Response to Agency Preliminary Comments on Labadie Energy Center §316(a) Draft Demonstration Study Report

Ameren Missouri has reviewed the comments provided by the Missouri Department of Natural Resources (MDNR) on behalf of the Agency and the Missouri Department of Conservation. It is our understanding that such comments also include feedback from Region VII of the United States Environmental Protection Agency (EPA) and the United States Fish and Wildlife Service (USFWS). Ameren also received comments from the EPA via email on December 4, 2019 from the MDNR. Ameren's responses to these comments are provided below. Some comments have also resulted in revisions to the Draft Demonstration Study Report and supporting materials (i.e., *Supplement to Labadie Energy Center Draft 316(a) Demonstration in Response to Agency Comments,* the "Supplement") which are referenced in the responses below. Ameren will plan to meet with MDNR in the near future to further discuss these comments and provide additional background.

Figure 1. Seasonal fraction of the fish community comprised of heat intolerant species as numbers (left) and biomass (right) in the vicinity of the LEC in 2017-2018.

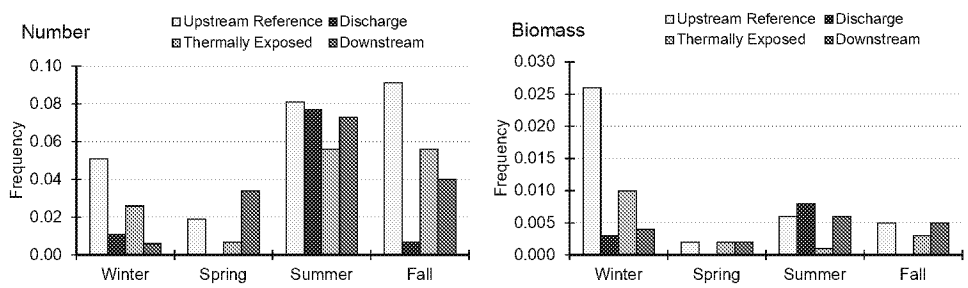
b. According to the text, there were no heat intolerant species counted in the discharge and thermally exposed areas, but Figure 5-19 appears to show the opposite.

c. In addition to this, please graph these by season as Section 6.3.3 indicates certain intolerant species will be completely absent if the river exceeds certain temperatures. Seasonal density graphs were completed for the macroinvertebrate community in Figure 5-24.

c. Graphs in Section 5 were selected to illustrate patterns in the data, without overwhelming the reader with more graphics than can be assimilated. The seasonal aspect of the prevalence of heat tolerant and intolerant species was incorporated into the analysis. The data for tolerant and intolerant species, segregated by gear and season, are provided in Appendix B Tables B-14 through B-17. The standardized differences between Upstream and either Thermally Exposed or Downstream zones, based on each of these combinations for fraction intolerant species are provided in Appendix B Tables B-18 through B-21. All of the standardized differences for each combination of gear x season, for both numerical abundance and biomass (without preference) were included in the overall weight of evidence, along with differences based on other metrics, in Figure 5-22.

To satisfy the request, figures similar to Figure 1 are provided in the Supplement (Section 3) to demonstrate the seasonal component of heat-intolerant species as it relates to numerical abundance and biomass.

Figure 2. Maximum temperature at the edge of the 25% Mixing Zone vs. TDP

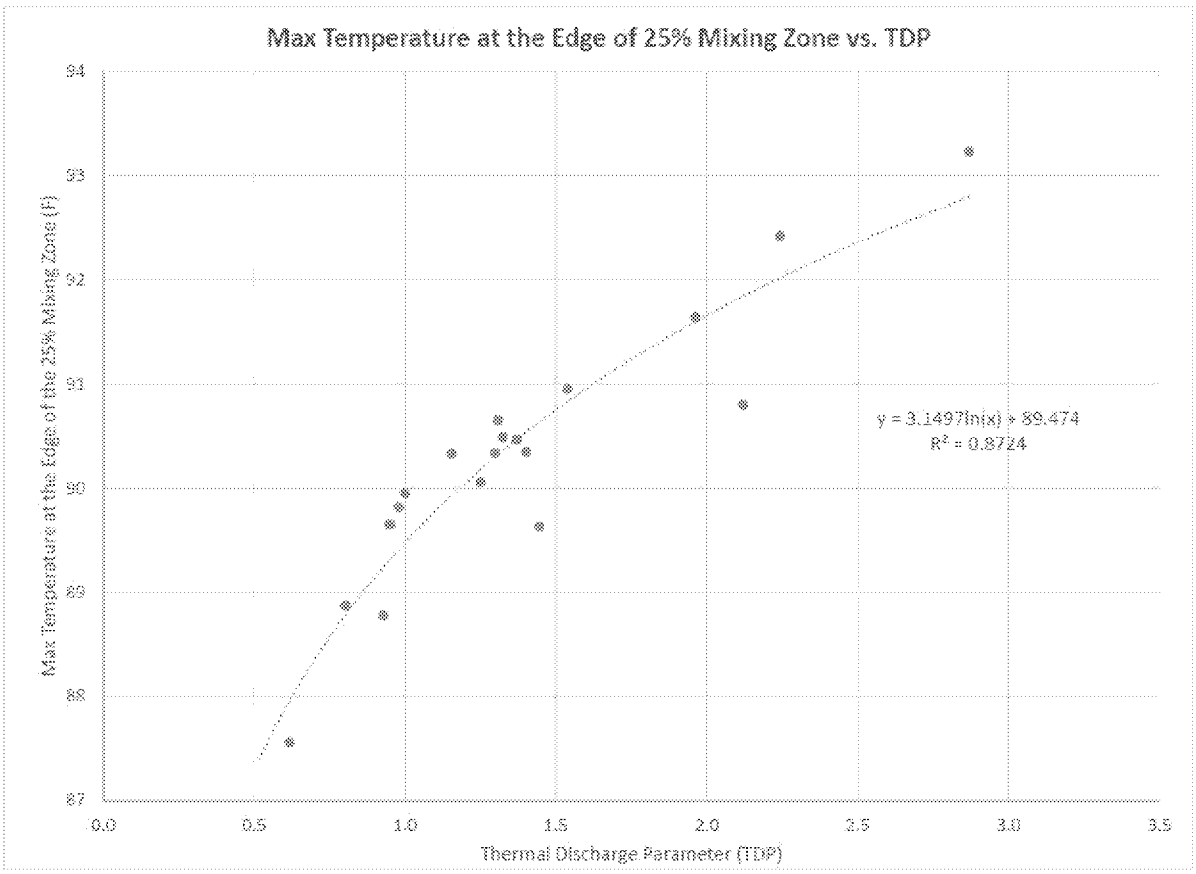
7. The Ameren variance request appears to be based on the logic of the Mississippi River criteria and this seems appropriate. The questions/comments below are based on that approach. While variable with river temperature, what is the more elevated temperature (>5°F) at the edge of the 25% mixing zone when the RMZ is expanded to 40% of the river? Does this equate to an additional 3°F increase above 90°F? Is the 40% value based on a calculated zone of passage or a maximum temperature at the higher RMZ? Ameren's variance request should define the increase in temperature above 90°F when the larger RMZ is allowed.

In response to this comment, we analyzed the model output from a subset of the previously conducted simulations that were run to develop the effluent limitation equations in Tables A-1 and A-2 of the NPDES permit. For each simulation, we determined the location along the river where the maximum temperature occurs after mixing with only 25% of the river flow. At all other locations, the temperature would of course be less than the maximum. The simulations analyzed represent a range of river and discharge temperatures and flows.

The results for the maximum temperature at the edge of the 25% mixing zone for each simulation are provided in the attached Figure. As expected, the Figure demonstrates that the maximum temperature is a function of the TDP. (Recall that the TDP is a composite measure of the combined effect of river and discharge flows and temperatures.) As can be seen, the maximum temperature at the edge of the 25% mixing zone will exceed 90°F at TDP values above 1, again as expected and as we have previously demonstrated. Nonetheless, the Figure further demonstrates that maximum temperature at the edge of the 25% mixing zone will always be below 94°F even for a simulation with TDP as high as 2.87. Analysis of the historical database (January 2002 – December 2018) indicates that TDP never would have exceeded 2.65. So, even when the variance may be invoked allowing temperature in the river to exceed 90°F in up to 40% of the river, the temperature will still be below 94°F in 75% of the river (i.e., be above 94°F in only 25% or less of the river), and will be below 90°F in 60% of the river (i.e., above 90°F in only 40% or less of the river). Furthermore, these maximum percentages will occur for only a small segment of the river and will be less at all other locations in the river.

For most instances during which the variance may be invoked the maximum temperature at the edge of the 25% mixing zone will only be one or two degrees above 90°F. For example, as shown in Figure 2, for a TDP value of 2.3, the maximum temperature at the edge of the 25% mixing zone will still only be about 92°F. And, TDP values at or above 2.3 would be extremely rare. The historical record shows that such has occurred on only 4 days out of 6018 days (less than 0.1% of the time). So, on days when the variance will be invoked, the maximum river temperature at the edge of the 25% mixing zone will typically be around one and almost always less than two degrees above 90°F, but never above 94°F.
